Access Compliance Report

Public Rights-of-Way

(Curb Ramps)

Intersection ID: 44909	Main Street: PALUSTRIS_CT	Cross Street: OAKBURN_DR	Location: SW
ADA ID: 354EFD4113	Ramp Type: PerpDiag	Initial Pass/Fail: Fail	Overall Compliance: No
			Severity Score: 33.75

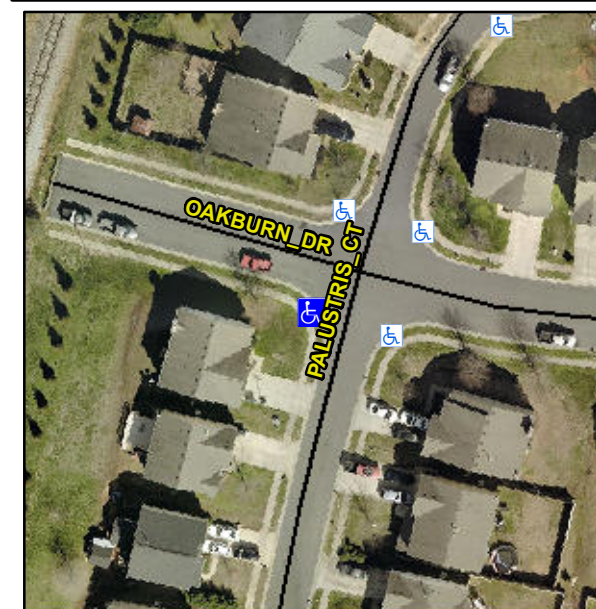
Not Found, R304.5.1, R304.5.3

Compliance	Description	Data	Compliance	Description	Data
N/A	Ramp Length (in)	46.0	Yes	Ramp Slope (%)	7.4
No	Ramp Width (in)	44.0	No	Ramp XSlope (%)	8.4
N/A	Flare Type LT	N/A	N/A	Flare Type RT	N/A
N/A	Flare Slope LT (%)	N/A	N/A	Flare Slope RT (%)	N/A
N/A	Flare Traversable LT?	N/A	N/A	Flare Traversable RT?	N/A
N/A	Landing Length (in)	N/A	N/A	DWS Provided?	N/A
N/A	Landing Width (in)	N/A	N/A	DWS Contrast?	N/A
N/A	Landing Slope (%)	N/A	N/A	DWS Length (in)	N/A
N/A	Landing X Slope (%)	N/A	N/A	DWS Full Width?	N/A
N/A	Landing Curb? (Y/N)	N/A	N/A	DWS Offset (in)	N/A
N/A	Shared Landing?	N/A			
N/A	Gutter Ponding?	N/A	N/A	Gutter Slope (%)	N/A
N/A	Gutter Lip Ht (in)	N/A	N/A	Gutter X Slope (%)	N/A
N/A	Painted X Walk1?	No	N/A	Painted X Walk2?	No
	X Walk 1 Direction	To SE		X Walk 2 Direction	To NE
N/A	X Walk 1 Width (in)	N/A	N/A	X Walk 2 Width (in)	N/A
	X Walk 1 Slope (%)	1.3		X Walk 2 Slope (%)	6.6
	X Walk 1 X Slope (%)	7.3		X Walk 2 X Slope (%)	3.8

Remove & Replace Curb Ramp With Two New Directional Ramps or Equivalent.
